Technical Review Committee Agenda

**CITY OF DELAND
THURSDAY APRIL 18, 2024 AT 1:30 P.M.
CITY OF DELAND TRC MEETING ROOM
DELAND, FLORIDA**

**CITY OF DELAND
TECHNICAL REVIEW COMMITTEE MEETING
MEETING MINUTES
THURSDAY, MARCH 21, 2024 - 1:30 P.M.
CITY HALL**

City of DeLand
PSB23-029
THE TOWNS
AT SUMMIT

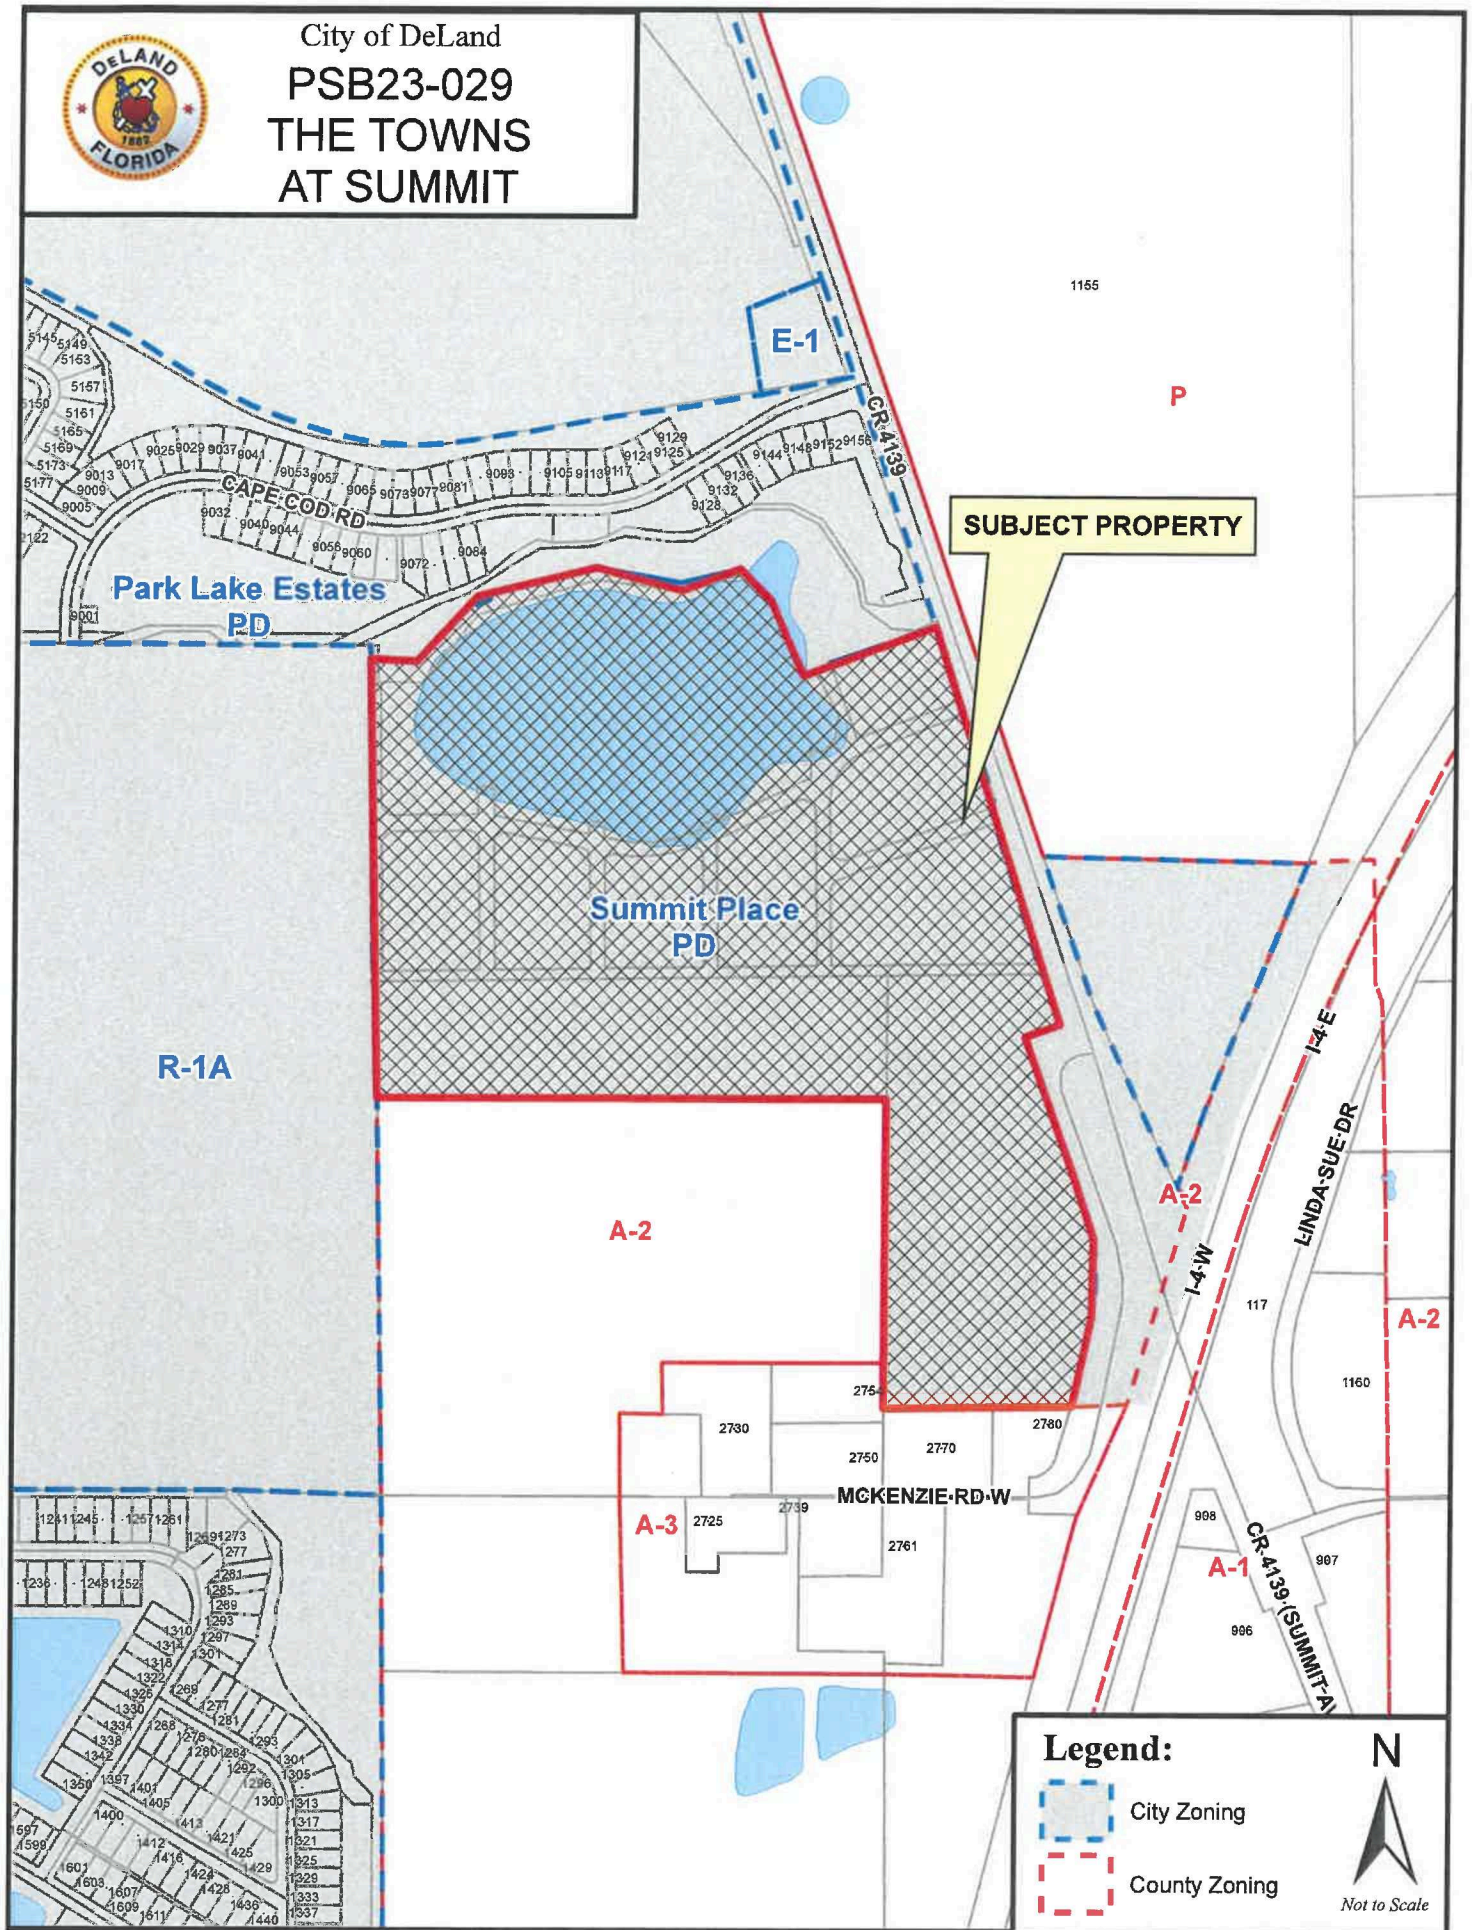
Discipline	Status	Details	Attached To	Created By	Last Updated By	Modifications Required
Engineering	Draft	Televised Storm Piping All storm piping shall be televised and provided to the City's Engineering Dept for review prior to final approval.	C003	Steven Danskine	Steven Danskine	Yes
Engineering	Draft	Inlet Placement Given the crowned road section, typically inlets will be placed on opposite sides of the roadway. One would typically expect to find an inlet across the street from STS-STRUC #34 near Sta 37+50. Please review.	C302	Steven Danskine	Steven Danskine	Yes
Engineering	Draft	Errant Callouts 1. Multiple Storm Structures are missing callouts. Please review for completeness. 2. The callout for P-44 points to a pipe that can only be seen on another sheet.	C302	Steven Danskine	Steven Danskine	Yes
Engineering	Draft	Control Structure Detail Inconsistencies The Control Structure Details are inconsistent in identifying components between the plan and section views, i.e. Invert Elevation, Control Elevation, Orifice Invert, etc. Also, the skimmer and bleed down orifice are not shown in the plan views.	C903	Steven Danskine	Steven Danskine	Yes

Engineering	Draft	Cross Section ID's Roadway cross sections call out Sheet C911. Please check references.	C903	Steven Danskine	Steven Danskine	Yes
Engineering	Draft	Orifice Size Inconsistent 1. The Orifice Sizing calculation indicates an orifice diameter of 3.80-in, but the detail on Sheet C903 shows an orifice size of 2.75".	Drainage Calculation Report.pdf	Steven Danskine	Steven Danskine	Yes
Engineering	Draft	Weir Elevation Inconsistent 1. The Design Weir Elevation of 64.35' does not match that shown in the plans, nor the ICPR Report of 64.00'. 2. No Orifice sizing calculation provided.	Drainage Calculation Report.pdf	Steven Danskine	Steven Danskine	Yes
Engineering	Draft	Structure Conflict 1. STS-STRUC #3? (Callout obscured) in front of units 172 and 173 appears to be in conflict with the proposed driveway apron shown on Sheet C402. Note: Please review for callout conflicts in the drawings.	C302	Steven Danskine	Steven Danskine	Yes

Engineering	Not Accepted	Pipe sizes and slopes 1. Please show storm pipe sizes and slopes on the plan sheets C301, C302, and C303. This is needed to check velocities requirements. Allowable velocity is based on latest FDOT Drainage Manual, Section 3.6.1, and should be between 2.5 to 15.0 feet per second (Manning's full flow).	C301	Tuan Huynh	Steven Danskine	Yes

Discipline	Status	Details	Attached To	Created By	Last Updated By	Modifications Required
		Last comment from reviewer: Please call out the pipe connecting OFF-01 and OFF-02. Last response: The requested information has been added to sheets C301 to C303. Pipe velocity is given in the drainage design report, Tab D. Drainage Calculations 1. Soils Map: please provide the soil ID and its percentage within the project limits. 2. Pre-Development Basin Map: show the project area limits using a color line type for clarity. 3. Pre-Development Basin Map: show the time of concentration path using color line type for clarity. 4. Pre-Development Basin Map: Label Tatum Lake on pre and post basin maps. 5. Pre-Development Hydrology: Basin FP-17A, please use exact curve number = 63.39 and not rounded number 63.0. Since the pre versus post discharges are very close in value it is best to use more precise CN values. Please do for all Pre and Post Basins for hydrology calculations and ICPR input. 6. Hydrology and ICPR Input: Hydrology FP-17A stage-storage spreadsheet top stage ends at 67.00, but ICPR node input continues to elevation 69.00. Hydrology and ICPR input data should match for consistency. 7. ICPR Input: Node FP-17B stage elevation should be input in ascending order to match other nodes input. 8. Hydrology and ICPR Input: Hydrology OFF-3 stage-storage data could not be found in the ICPR node input. 9. Hydrology and ICPR Input: Hydrology DP-2 stage-storage spreadsheet top stage ends at 76.00, but ICPR node input continues to elevation 77.00. Hydrology and ICPR input data should match for consistency. 10. Pre ICPR Node Min/Max Report: Please highlight or box the 25yr-24hr storm maximum total inflow result (116.77 cfs) for node FP-17A to support Pre versus Post discharge summary table in Appendix A. 11. ICPR Input: Please use same name ID for drop structure CS-SMA1 to match the plans, and drainage report to avoid confusion. For example, in ICPR model it is called CS-SMA1 but plan sheet C911 and drainage report narrative it is called CS-01. Do likewise for CS-SMA2, which is called CS-02 on the plans and drainage report narrative. Last comment from reviewer: Item 7 not corrected as noted. Item 11 not consistent between plans and report. Last response: The drainage calculations have been revised as follows: 1. On page 9, the soils map has been updated with ID and percentage. 2. On page 16, the pre-development map has been updated with a magenta color project boundary. 3. On page 16, the pre-development map has been updated with cyan color lines for Tc paths. 4. On page 16, the pre-development map has been updated to label Lake Tatum. 5. On page 31, the pre-development ICPR model has been revised to use a CN of 63.40 for basin FP-17A, which is consistent with the calculations shown on page 18. 6. On page 18, the stage/storage data for Node FP-17A has been revised to include a top elevation of 69 feet, consistent with the ICPR model.

Forestry	Draft	Median Trees Who will be responsible for infrastructure damage (pavement, curbs, utilities) that is caused by the median trees?	L2	Kit Dennis	Kit Dennis	Yes
Forestry	Draft	Right of way Trees There are several locations that show trees (standard Grape Myrtles) being planted between the curb and sidewalk. These trees should be moved out of the right of way as we do not allow trees to be planted in these areas do to the future infrastructure damage they can cause.	L0	Kit Dennis	Kit Dennis	Yes
Forestry	Draft	Updated Numbers Needed Please provide updated numbers when all tree comments have been addressed. 1788/2 = 894" DBH. You may also be missing some specimen trees on your survey due to missing cedar trees.	SUMMIT PLACE CITY TREE REPORTS 02 20 2024.pdf	Mariellen Calabro	Mariellen Calabro	Yes
Forestry	Draft	Tree Replacement Required Add a summary table of tree inches removed, tree inches provided, and Tree Replacement Reserve Account contribution to the plans. It doesn't have to be on this page, but it needs to be somewhere in the plan set.	T3	Mariellen Calabro	Mariellen Calabro	Yes

Forestry	Draft	Wetlands and cedars Please add cedars to list of specimen trees and add wetlands to legend.	T3	Mariellen Calabro	Mariellen Calabro	Yes
Forestry	Draft	Wetlands and cedars Please add cedar to list of specimen trees and add wetlands to legend.	T2	Mariellen Calabro	Mariellen Calabro	Yes
Forestry	Draft	Specimen Trees Cedar trees 12" DBH or larger are considered specimen. Please update this list and update your tree summary table. See page 10 of 44 on your tree replacement spreadsheet. Unfortunately, there are two rows with cedars as protected, but not	T1	Mariellen Calabro	Mariellen Calabro	Yes

Forestry	Draft	Tree Protection Notes & Tree Barricade Detail Please replace this information with City of DeLand Tree Barricade Detail and requirements.	C011	Mariellen Calabro	Mariellen Calabro	Yes
Forestry	Draft	Tree Save Areas If these areas are designated as Tree Protection Areas, please label them as such. Also, please fix spelling of greater on the first line of the HATCH LEGEND.	C011	Mariellen Calabro	Mariellen Calabro	Yes
Forestry	Draft	Tree Save Areas If these areas are designated as Tree Protection Areas, please label them as such. Also, please fix spelling of greater on the first line of the HATCH LEGEND.	C010	Mariellen Calabro	Mariellen Calabro	Yes
Median and entrance feature trees Who will maintain the trees at the entrance and in the median?						
Forestry	Not Accepted	Last comment from reviewer: Please add a note indicating that the median, street trees, and entrance plantings will remain the maintenance responsibility of the HOA. Last response: The HOA will maintain landscaping located in roadway medians.	L2	Mariellen Calabro	Mariellen Calabro	Yes

Tree Protection Areas Show Tree Protection Areas on the plat.						
Forestry	Not Accepted	Last comment from reviewer: Plat has not been revised. Last response: The preliminary plat will be revised to show tree protection areas.	PLAT 1	Mariellen Calabro	Mariellen Calabro	Yes

Last response: The mitigation cost has been changed from \$55/inch to \$75/inch, please see updated OVERALL TREE REPLACEMENT CALCULATIONS.				
Forestry	Not Accepted	Tree Coverage Area Minimum Tree Coverage needs to be recalculated based on the entire project area minus the lake.	L1	Mariellen Calabro	Mariellen Calabro	Yes
		Last comment from reviewer: Minimum coverage should be calculated based on total project area minus the lake. This should result in a requirement of 4,844" DBH.				
		Last response: Based on code section below and working with the City Forester we are deducting the Wetland Area in addition to the Lake from the Tree Coverage Area.				
Forestry	Not Accepted	Tree Protection Area Tree Protection Area is calculated based on the entire project area. You can remove the area of the lake from the calculations, but wetlands and proposed stormwater ponds cannot be removed from calculations.	L1	Mariellen Calabro	Mariellen Calabro	Yes

Last comment from reviewer: Your Tree Protection Area and Minimum Coverage requirements should be based on the total project area (59.90 acres) minus the lake area (13.57 acres), which would result in an area of 47.33 acres, requiring 6.95 acres of Tree Protection Area and 4,844" DBH or minimum coverage. If you are excluding the wetland from being considered as part of the impact area per conversation with City Forester, please confirm that they are also not being counted as TPA. Also, please add the wetland area to the legend.				
		Last response: Based on code section below and working with the City Forester we are deducting the Wetland Area in addition to the Lake from the Tree Coverage Area.				
Forestry	Not Accepted	Natural Tree Save Area Please label this as Tree Protection Area if this is its intended use.	C100	Mariellen Calabro	Mariellen Calabro	Yes

Planning	Draft		C102	Emily Ragusa	Emily Ragusa	Yes
Rear loaded/Porches Consider adding porches on some of the units and making all or some rear loaded to make a more attractive product and community.						
Planning	Draft		CS PEARSON_4 -UNIT	Emily Ragusa	Emily Ragusa	Yes
Buffer The Emerging Gateway Overlay requires a minimum 40-ft buffer. The proposed plan does not reflect 40-feet in all locations.						
Planning	Not Accepted	Last comment from reviewer: The First Amended and Restated Summit Place PD has not been approved yet, therefore the 40' Emerging Gateway Overlay requirement will need to be met. Last response: The proposed buffers are in accordance with the First Amended and Restated Summit Place PD	L0	Melissa Winsett	Emily Ragusa	Yes
Building Setbacks The R-16 zoning classification requires a minimum front setback of 30-feet and rear setback of 40-feet. Last comment from reviewer: The First Amended & Restated Summit Place PD has not been approved yet. Therefore, the R-16 setbacks will need to be met.

Last response: The Summit Place PD has been revised. The current document is the First Amended and Restated Summit Place PD.						
Summit Ave Driveway The proposed driveway on Summit Ave requires a county use permit and TIA. Please see TIA-related comments. Note: A right turn lane will be required by the county. Please include this on the revised plan. A left turn lane may also be required based on the results of the TIA.						
Planning	Not Accepted	Last comment from reviewer: Provide a copy of the USE permit and TIA to the City when obtained.	C100	Melissa Winsett	Emily Ragusa	Yes

1) The total units don't match the Phase 1- and 2-unit count. 2) Per the Multifamily setbacks in the R-16 zoning classification, the front setback is 30-feet and rear setback is 40-feet.						
Planning	Not Accepted	Last comment from reviewer: The First Amended and Restated Summit Place PD has not been approved yet. Therefore, the R-16 setbacks must be met. (Front: 30ft & rear: 40ft)	C100	Melissa Winsett	Emily Ragusa	Yes
Last response: Comment acknowledged. The total units have been updated on Sheet C100, Overall Site Plan, to correctly reflect 300 proposed units between Phase 1 & 2. The proposed setbacks are in accordance with the First Amended and Restated Summit Place PD.						
Building Spacing						
Revise building spacing to meet page 9 of the development agreement. The minimum spacing is 25-ft.						
Planning	Not Accepted	Last comment from reviewer: The First Amended and Restated Summit Place PD has not been approved yet. Therefore, the minimum building spacing of 25-ft must be met.	C100	Melissa Winsett	Emily Ragusa	Yes

Missing Items on Plan						
Planning	Not Accepted	Future Land Use, Emerging Gateway Overlay, Zoning, Impervious Surface Ratio, Allowed Density & Proposed Density. Maintaining authority/owner of adjoining roads.	C100	Melissa Winsett	Emily Ragusa	Yes
Last comment from reviewer: Include the size of Lake Tatum (in acres & percentage) in the impervious surface table.

Planning	Not Accepted	Last comment from reviewer: Provide the square footage of the amenity building to ensure the appropriate number of parking spaces are proposed.	C100	Melissa Winsett	Emily Ragusa	Yes
Last response: The parking proposed for the pool is designed to meet City code. The Applicant wishes to keep the pool as currently located.						
Parking Requirements Provide parking calculations in the site data. Include the required parking and proposed. Per Section 33-91.03(f), Multifamily units require 0.5 visitor spaces and between 1 and 2 resident spaces per unit. Please check the code and revise the plan. Also include handicapped parking information.						
Planning	Not Accepted	Last comment from reviewer: The First Amended and Restated Summit Place PD has not been approved yet. Therefore, at this time the guest parking requirement of 0.5 spaces per unit will need to be met.	C100	Melissa Winsett	Emily Ragusa	Yes

General Notes Related to all architectural sheets, please correct the General Notes, #1 to include consistency not only with the building code but also the development agreement, the Lake Winnemissett Gateway Corridor local plan, and the City's Community Design Standards.						
Planning	Not Accepted	Last comment from reviewer: Applicant submitted generic master copy for submittal. At time of building permit, the General Notes, #1 to include consistency not only with the	CS PEARSON_4 -UNIT	Melissa Winsett	Emily Ragusa	Yes

Required items Please provide color swatches, any exterior building signage, and material and texture indications. Include any fences and walls, site furnishings, specified pedestrian access paving, etc. Architectural building elevations must be in color per the Community Design Standards. Section 33-94.						
Planning	Not Accepted	Last comment from reviewer: Updated elevations to be submitted adhering to LDR Sec. 33-94. Enhance the exterior of the buildings with architectural features. Last response: Noted. The Applicant will consider the City's request and provide updated elevations for review.	CS PEARSON_4 -UNIT	Melissa Winsett	Emily Ragusa	Yes

Comment from City Architect (3-8-23) Per the PD requirements, which are also taken from the design standards (94.03 (a)5), the massing of all the buildings is very monotonous. Something should be done to vary the massing of the long straight rows of the same building.						
Planning	Not Accepted	Last comment from reviewer: The exterior of the buildings shall be enhanced with architectural features to included a variety of colors, materials, eliminating monotony and long straight rows of the same building. Last response: Noted. The Applicant will consider the City's request and provide updated elevations for review.	CS PEARSON_4 -UNIT	Melissa Winsett	Emily Ragusa	Yes
Building Design and Architecture Page 9 of the development agreement requires building design, scale and details to be designed architecturally from both the pedestrian and vehicular points of view. Box and rectangular structures with blank walls are to not permitted. Additionally, multiple buildings on a single site shall provide for a variety of spacing between structures and monotonous repetition of identical structures shall be avoided. The proposed architecture lacks varied building design and is monotonous. The buildings are flat and unarticulated, lacking varied materials and wall planes. Consider porches on some of the units.
